Product Change Notification / SYST-31TCNJ739

ERRATA - PIC18F27/47K40 Family Silicon Errata and Data Sheet Clarification

PIC18(L)F27/47K40 Family Silicon Errata and Data Sheet Clarifications

Figure 1. 28-pin SPDIP, SSOP, SOIC

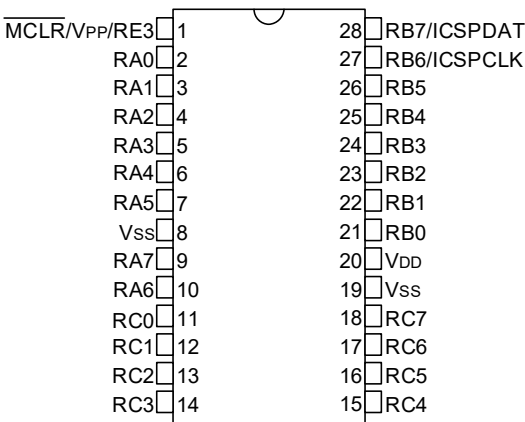
3.2.1 28-pin SPDIP/SSOP/SOIC Pin Diagram

The correct marking for pin 26 on the 28-pin SPDIP/SSOP/SOIC package is **RB5**.

Figure 3. 40-pin PDIP

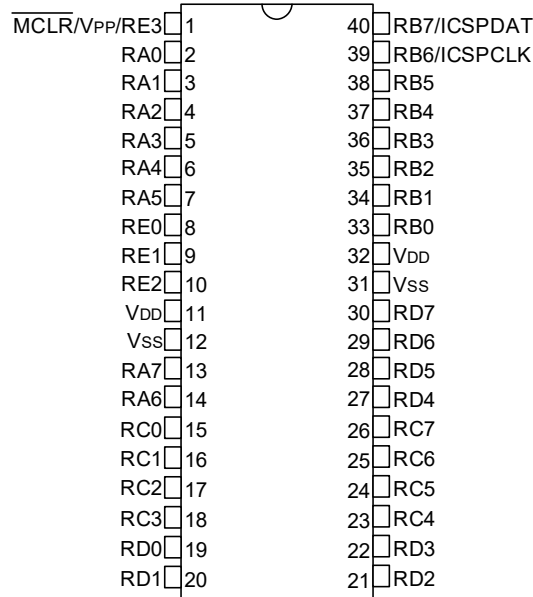
3.2.2 40-pin PDIP Pin Diagram

The correct marking for pin 38 on the 40-pin SPDIP package is **RB5**.

Figure 38-10: ADC Conversion Timing (ADC Clock F_{OSC} -Based)

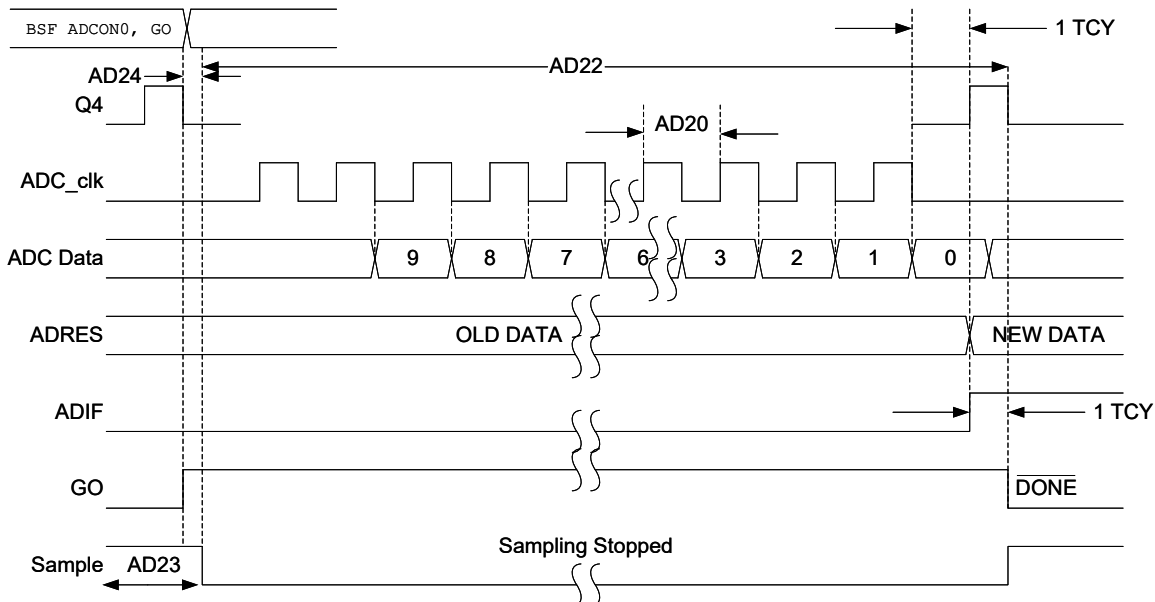
3.3.2 ADC Conversion Timing Diagram

Refer to the images below for corrections of Figure 38-10 and Figure 38-11. Previously, the parameter numbers were incorrect.
